# ADDENDUM # 2

## North Ward Park – FB18184

North Ward Park Project Question & Response:  
January 4, 2018

1117 - 6" MONOLITHIC CURB @

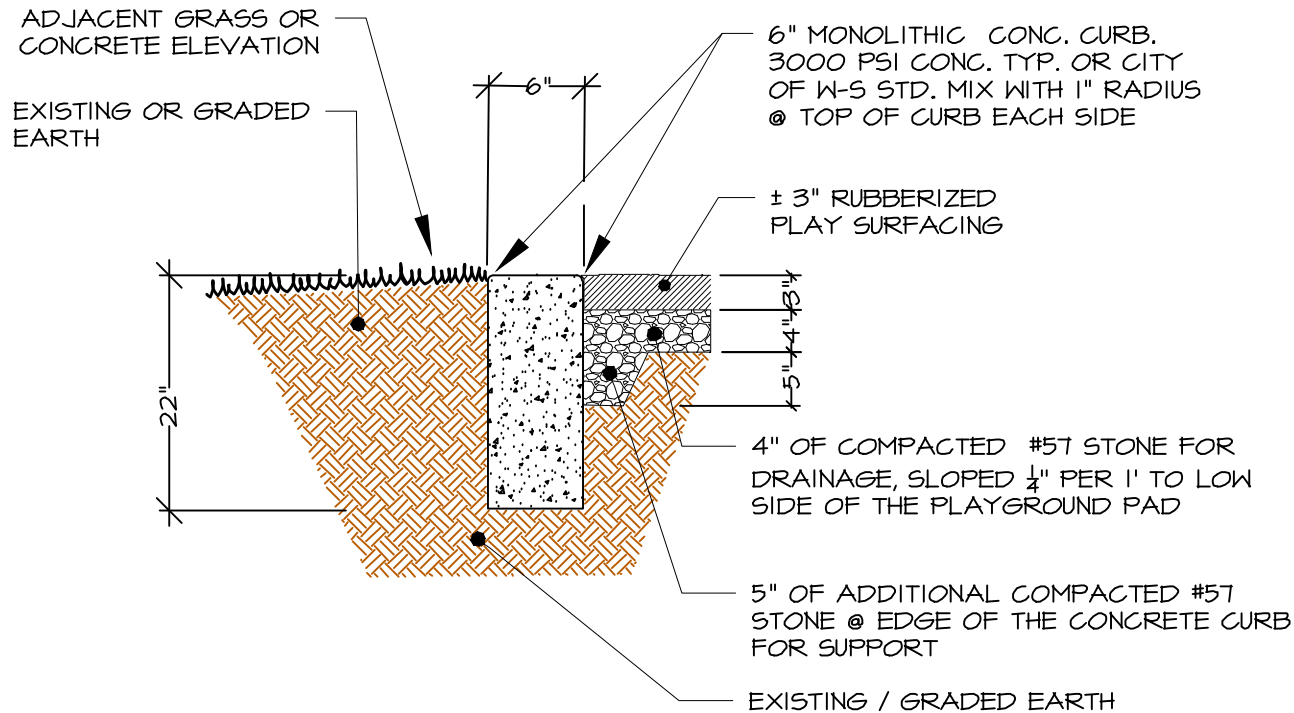
13	1/2/18	1	<i>Is the sanitary sewer tying into the 8" clay pipe that is across the street from the project? Are there any manholes in that area that we can tie into? If not, does the City have a detail for how we are supposed to tap an active clay line?</i>	Yes, there is 1 manhole, the engineer prefers to make the tie/tap at the location shown for bid purposes. Yes the City of WS has a detail on how to tap an active clay line. See (link) for clarity. Detail for 4" Sewer Connection (revised 3/1/17) <a href="http://www.cityofws.org/Departments/Engineering/Publications">http://www.cityofws.org/Departments/Engineering/Publications</a>
14		2	<i>There are not any details about the subgrade for the playground. The playground subcontractor stated that we need to provide a 4" compacted base and sub drainage. Will there be sub drainage for the playground or do we just provide a ¼" per foot slope on the compacted material? We also need a detail for the vertical concrete curb that is shown in the conceptual detail for the playground. The site plan does not note or show the vertical curb.</i>	At this time, you are to provide a 4" compacted #57 stone base that slopes ¼" per foot to the lower side of playground pad for drainage. See concrete curb detail "1117- 6" Monolithic Curb @ Playground Detail" attached for your use.

1. 6" THICK CONCRETE MONOLITHIC CURB @ 3,000 PSI
2. ALL CONTROL JOINTS TO BE TROWELED TO A DEPTH OF 1- $\frac{1}{2}$ " MINIMUM IN CONCRETE CURB
3. CONTROL JOINTS TO BE 10' O.C. MAXIMUM.
4. 1/4" PRE MOULDED PVC OR EQUAL EXPANSION JOINT WHENEVER CONCRETE CURB MEETS FIXED OBJECTS (I.E. CURBS, BUILDINGS, CONCRETE WALKS, CONCRETE PADS, ETC.) EXPANSION JOINTS TO BE A MAXIMUM OF 20' O.C.
5. LIGHT BROOM FINISH.
